SUBJECT: AMENDMENT NO. 207 TO FACILITY OPERATING LICENSE NO. NPF-3 -
DAVIS-BESSE NUCLEAR POWER STATION, UNIT NO. 1 (TAC NO. M93816)

Amendment No. 207
License No. NPF-3

SAFETY EVALUATION BY THE OFFICE OF NUCLEAR REACTOR REGULATION
RELATED TO AMENDMENT NO. 207 TO FACILITY OPERATING LICENSE NO. NPF-3

DAVIS-BESSE NUCLEAR POWER STATION, UNIT NO. 1

Figure 3.1-1 Boric Acid Addition System
Minimum Required Volume as
a Function of Boric Acid
Concentration Required in
Modes 1-4

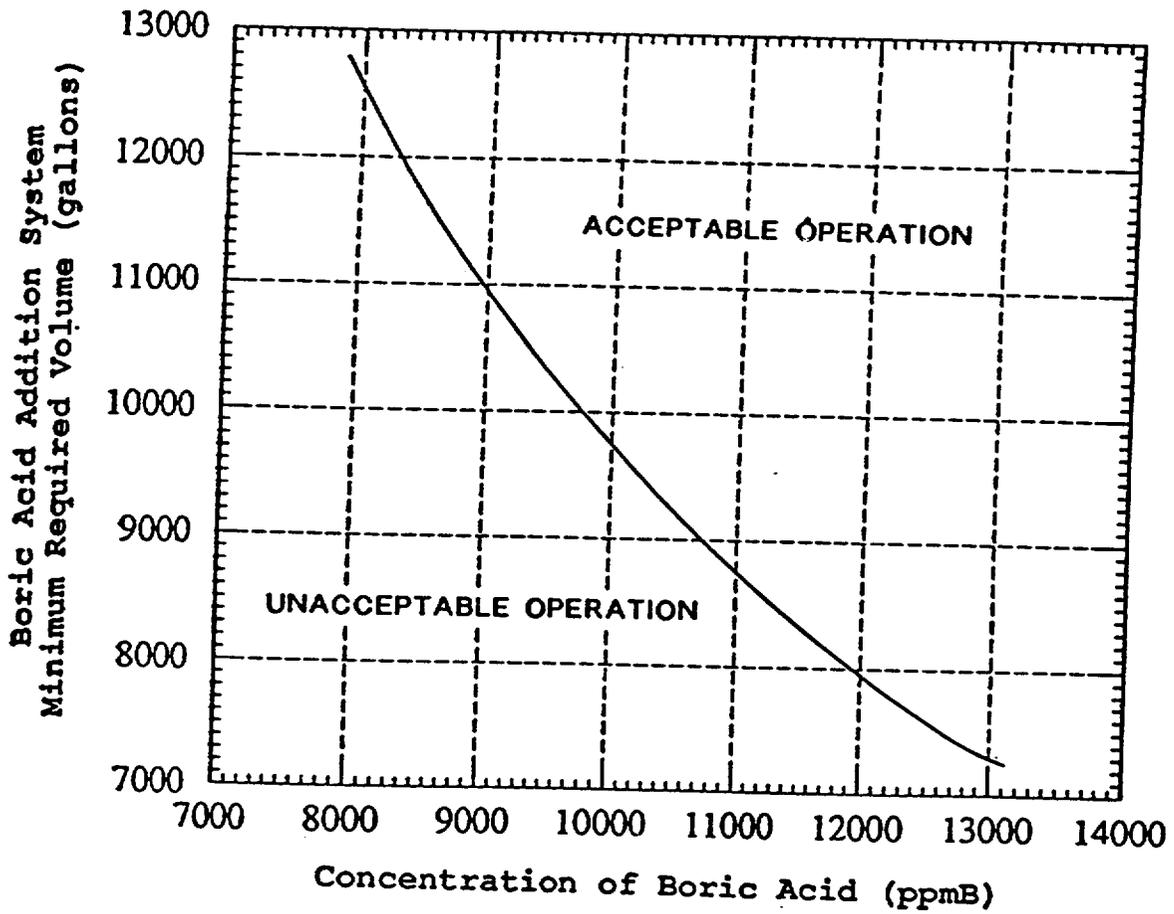
It is proposed to revise Figure 3.1.1, "Boric Acid Addition System Minimum Required volume as a Function of Boric Acid Concentration Required in Modes 1-4," in order to increase the minimum required volume.

For the maximum boration requirements from HFP to 200°F, it is proposed to increase the minimum volume requirement for the BAAS from 9,071 gallons at a minimum boric acid concentration of 7875 ppm to 12,200 gallons, and to increase the minimum volume requirement for the BWST from 75,300 gallons at a minimum boron concentration of 2100 ppm to 86,700 gallons at a minimum boron concentration of 2600 ppm. It is also proposed to add a statement explaining why the volume requirement of 12,200 gallons is a lower value than that shown in TS Figure 3.1-1.
